**NOTICE OF DECISION TO CONSENT TO CHANGE TO PROPOSAL DURING
ASSESSMENT**

Miralga Creek DSO Project
Assessment No. 2246

STATEMENT OF REASONS

Proposal: Miralga Creek DSO Project

Attachment 1: Changes to the proposal – Miralga West

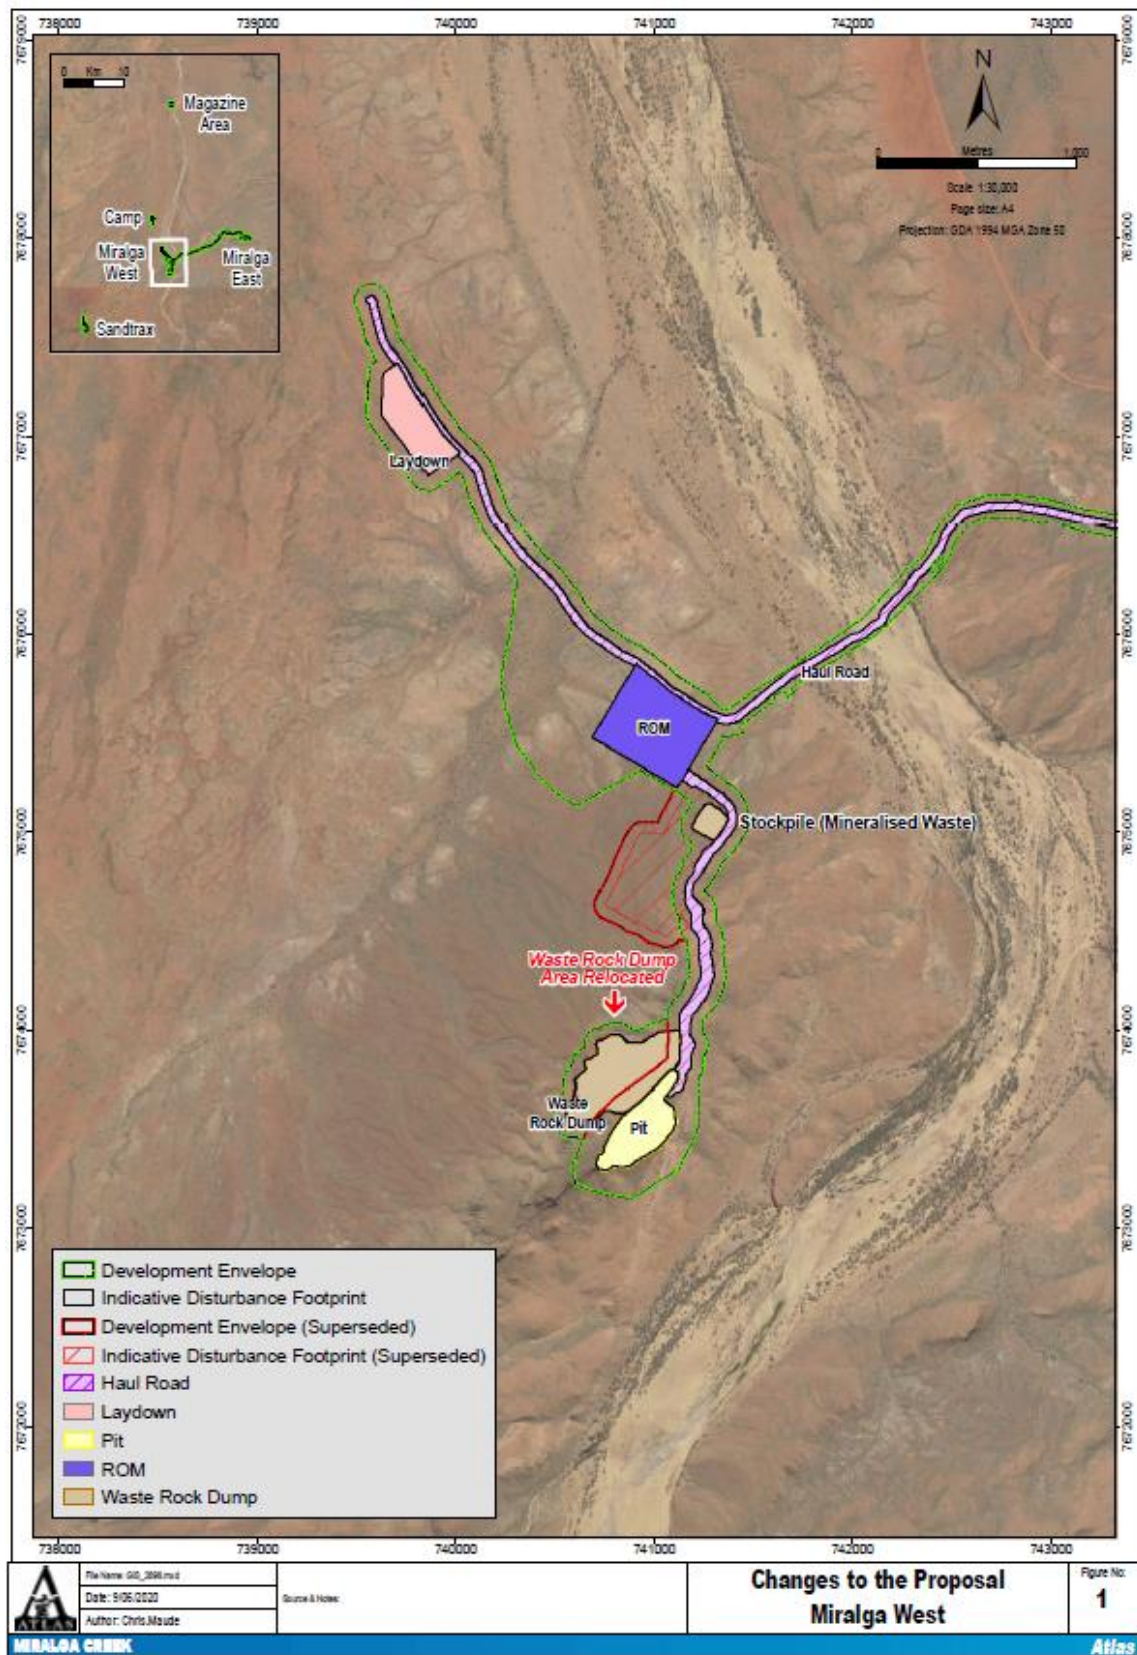
- **Relocation of the Miralga West waste rock dump (WRD).**
 - The change was made to eliminate the need to haul waste rock over 1 km from the open pit at the top of the ridge to the WRD at the bottom of the ridge. The change is expected to increase the efficiency of operations by reducing vehicle emissions and costs.

The relocation of Miralga West WRD to a new location adjacent to the pit. It is not expected to result in any significant new environmental impacts. Reduction in haul distances, increase in efficiency and reduced vehicle costs and greenhouse gas emissions.

Attachment 2: Changes to the proposal – Accommodation Camp

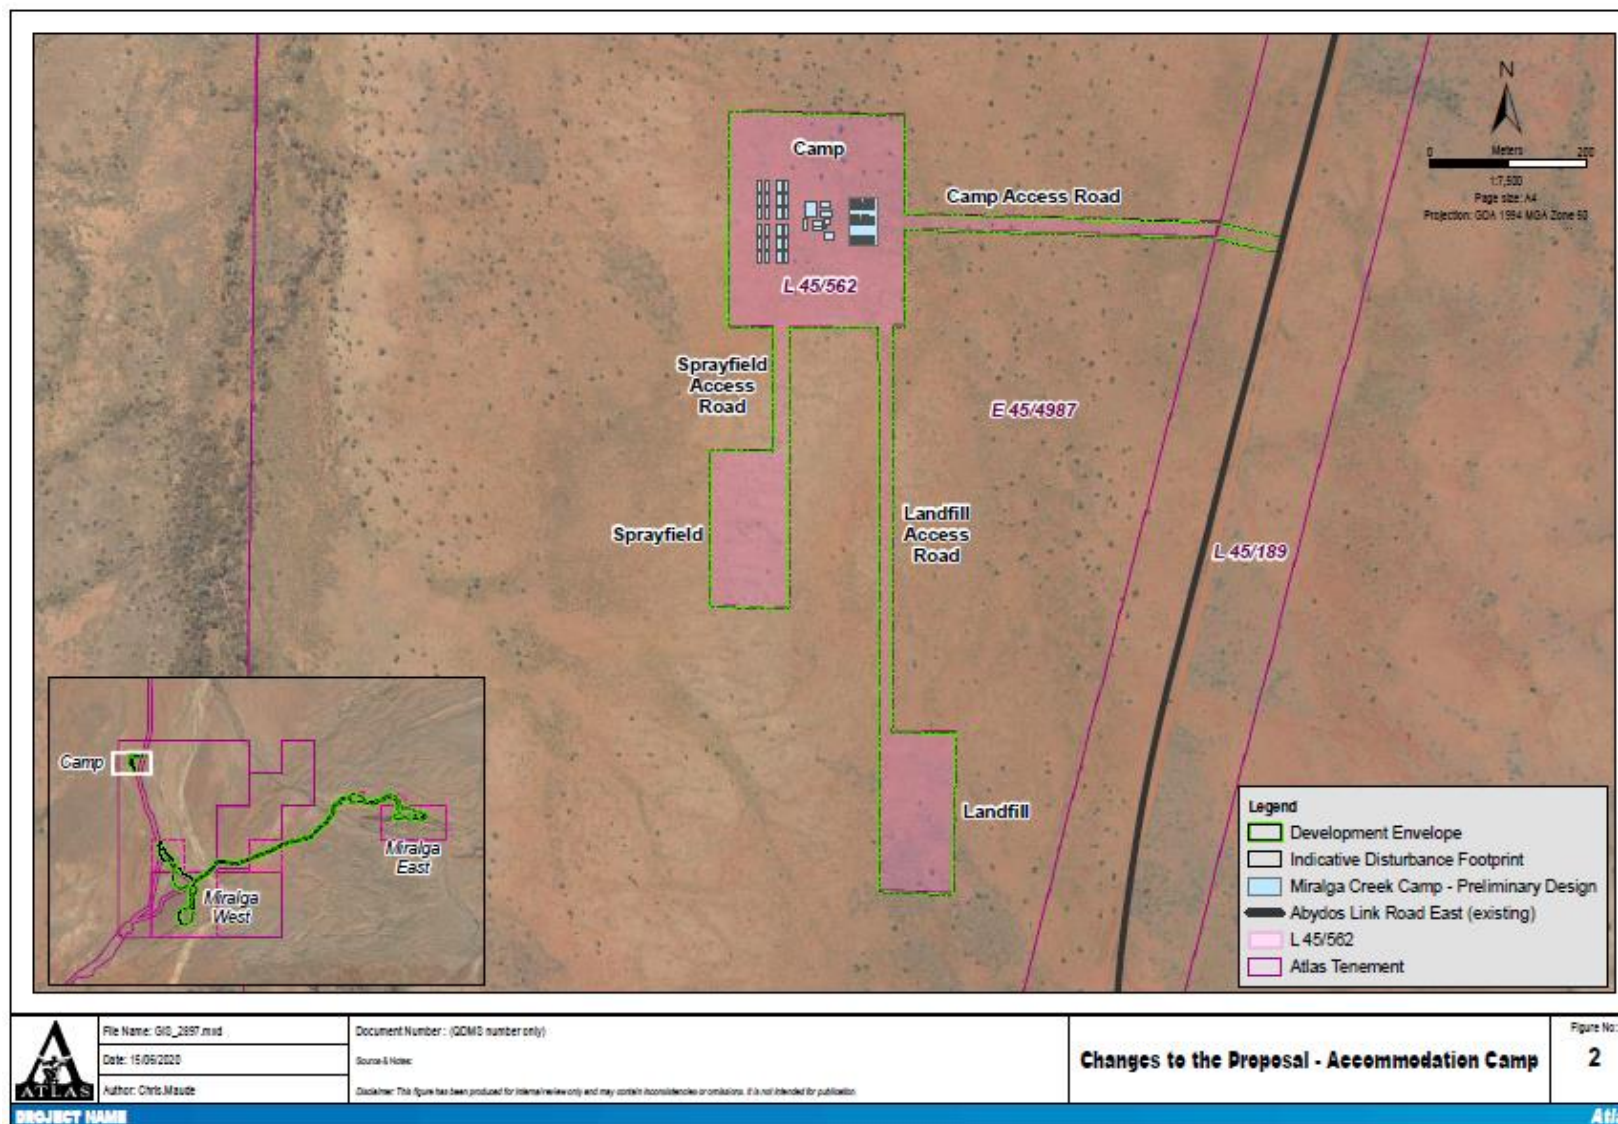
- **Addition of an accommodation camp and associated infrastructure.**
 - The proponent has reviewed the original proposal and the use of the existing Abydos camp site and has found that the camp may not be the most suitable option for the proposal, due to its distance (over 40 km from Miralga East), existing arrangements for use of third parties and the potential for the Mt Dove camp infrastructure to become available in the near future.

- The new camp proposed will be located 7 km north of the Miralga West ROM pad and west of the Abydos Link Road East. The camp will accommodate up to 80 people and include wet/dry messes, offices, gym, laundries, maintenance yard and diesel power generation.

- It will require the following facilities:
 - potable water treatment and storage,
 - wastewater treatment plant (WWTP) and irrigation spray field
 - landfill.

Attachment 3: Changes to the proposal – Stockyards

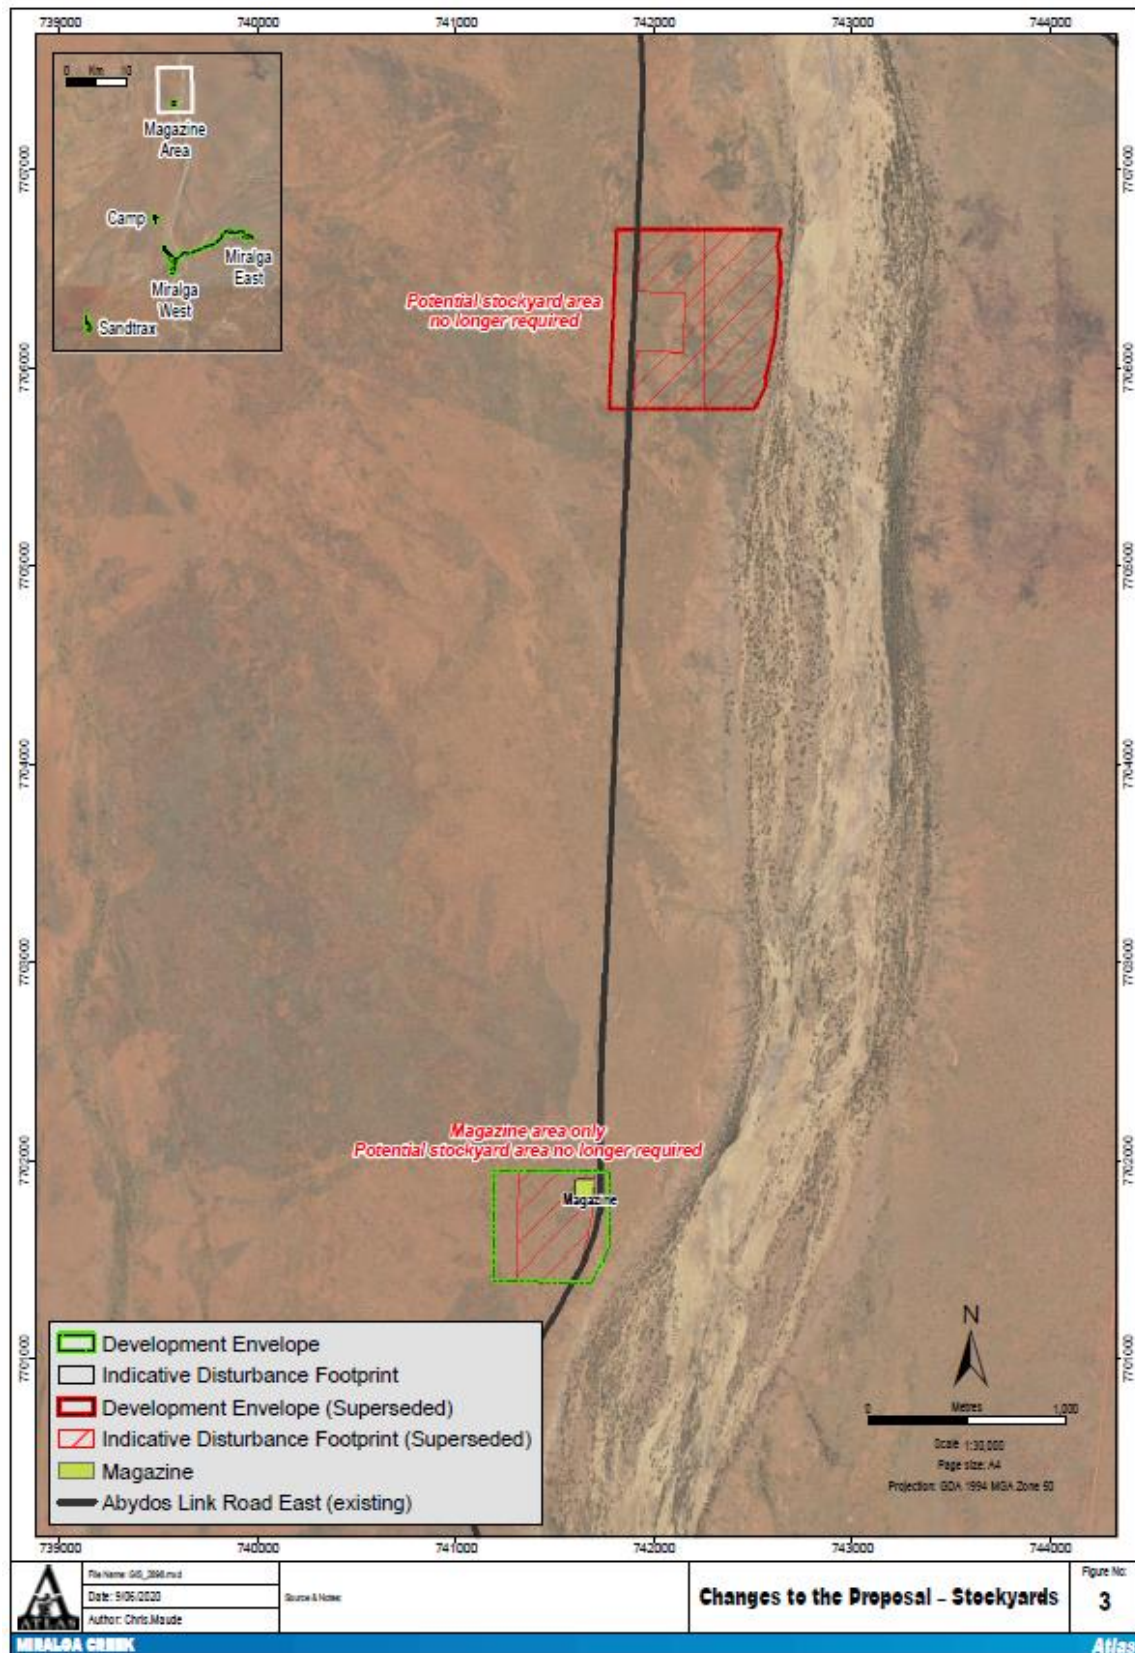
- **Removal of potential stockyard areas.**

- Changes to the proposed operations mean these stockyards are no longer required. Product stockpiling will instead occur at Miralga West.
- The northern (larger) stockyard has been removed from the indicative disturbance footprint and development envelope. The southern (smaller) stockyard has been removed from the indicative disturbance footprint, however the explosives magazine has been retained and the development envelope is unchanged in this location as it aligns with the proponents underlying general purpose tenement G45/340.

Attachment 4: Changes to the proposal – Development envelope and indicative disturbance footprint

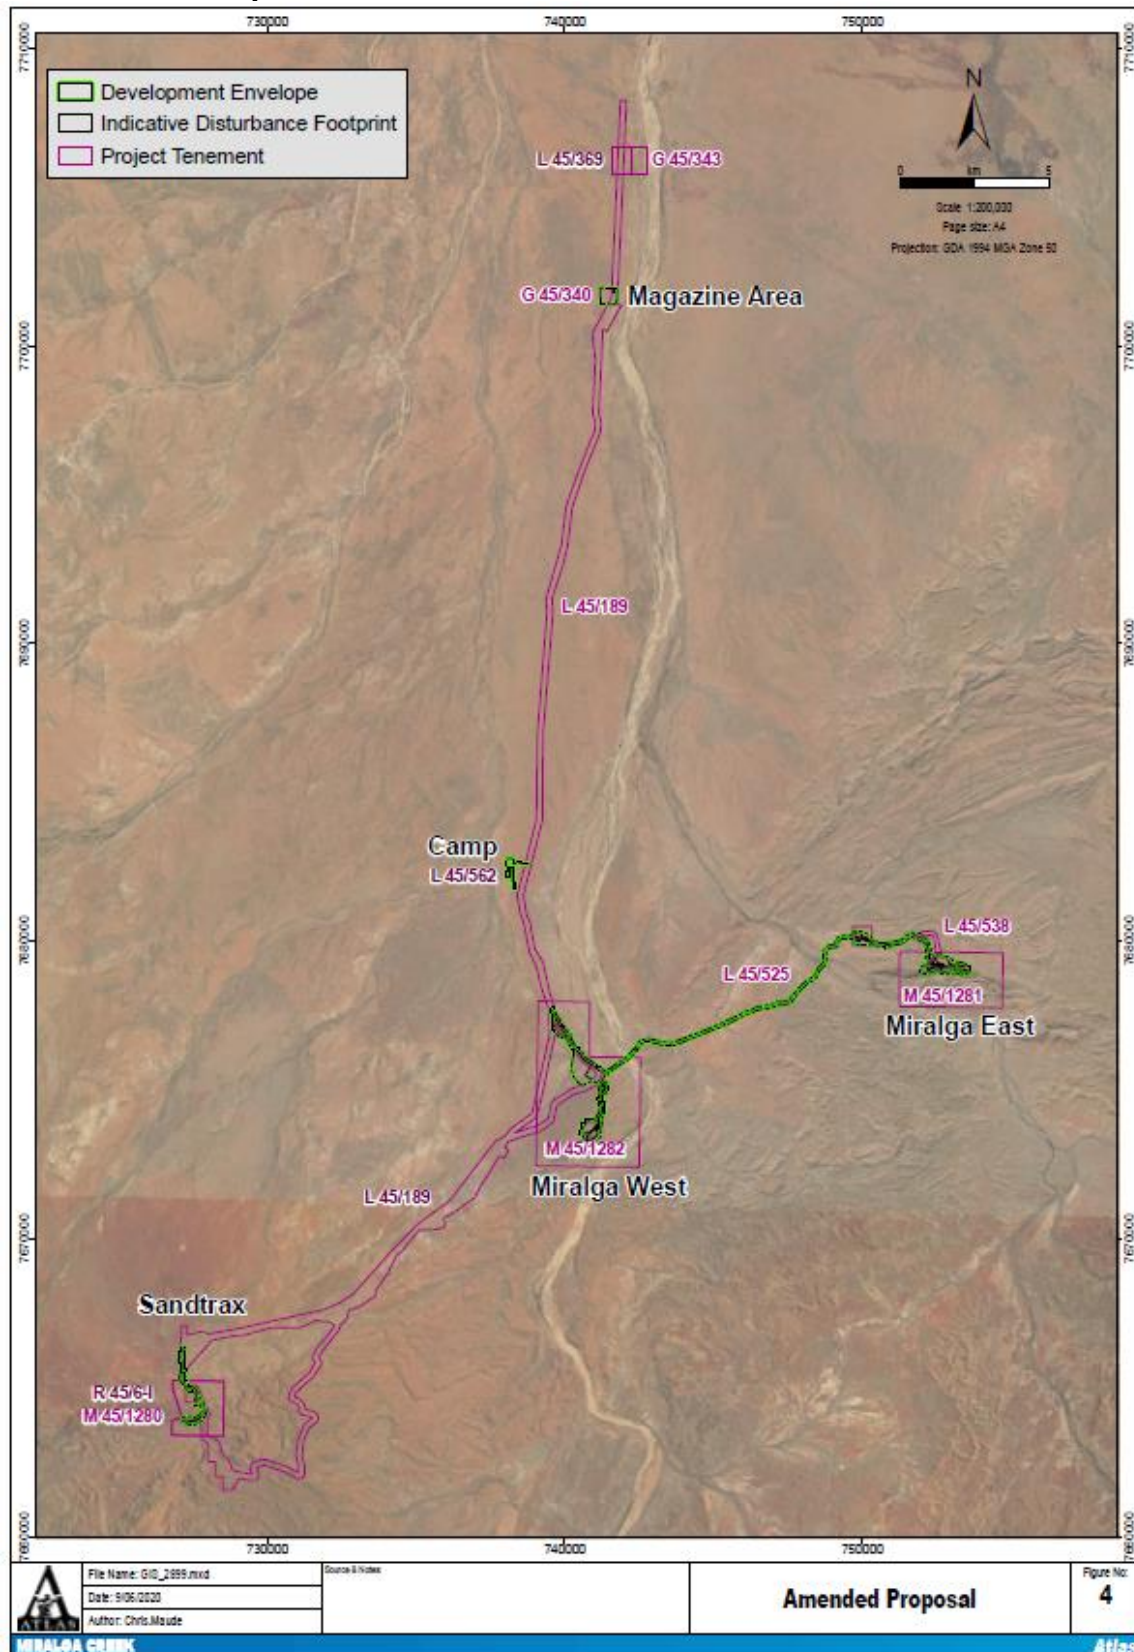
The proposed changes will result in an overall decrease in total area of the development envelope from 621.1 ha to 556.8 ha, compared to the original proposal this is a 64.3 ha (10 %) reduction. A reduction of clearing in the inductive disturbance footprint from 284.9 ha to 219.8 ha, compared to the original proposal this is a 65.1 (22 %).

Attachment 2: Changes to the proposal – Accommodation Camp

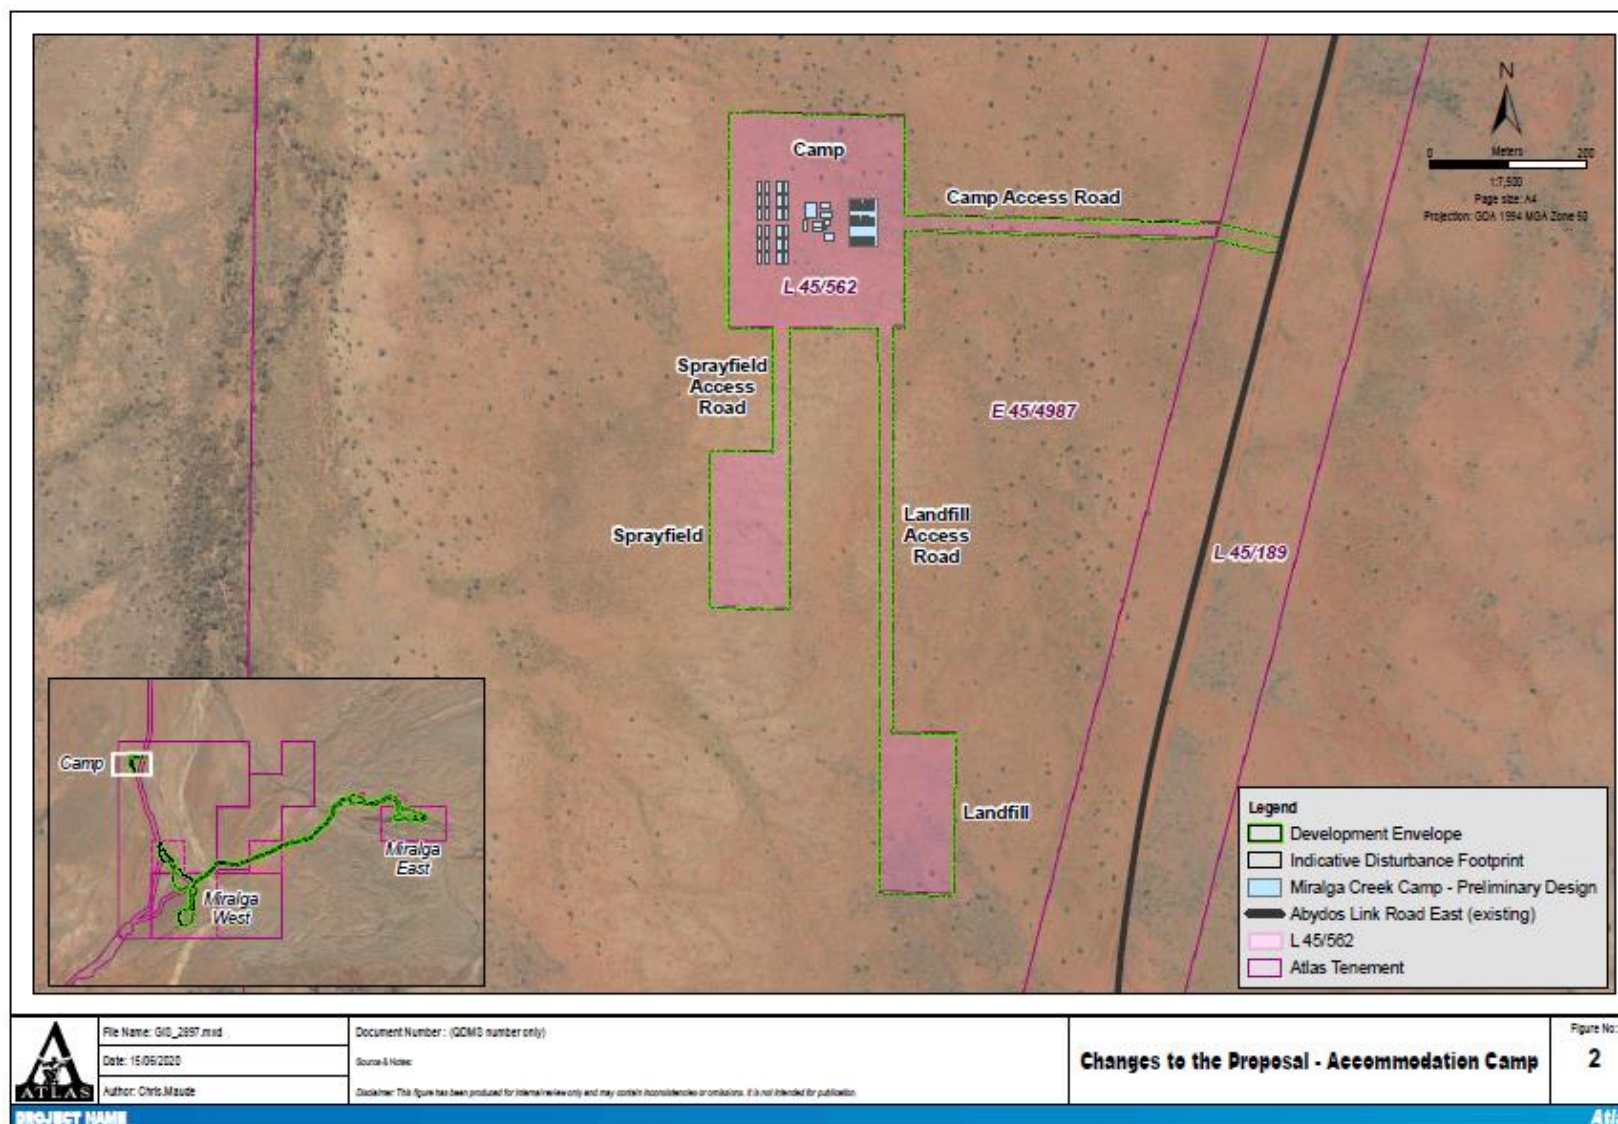
Addition of the accommodation camp will require clearing of 12.2 ha, but this is offset by the 72.5 ha decrease in clearing with the removal of stockyards. There are no records of conservation significant flora in the areas added to the development envelop and inductive disturbance footprint. Impacts to Groundwater Dependent Vegetation (GDV) from drawdown as presented in the original proposal were calculated on the extent of Vegetation Type 5 (VT5) within the 0.5 m drawdown contours. As the additional water requirement for the camp represents a 0.8 % increase in the proposals total water requirement, the change to drawdown contours would be negligible and the change in predicted impact of groundwater drawdown on GDV is considered negligible.
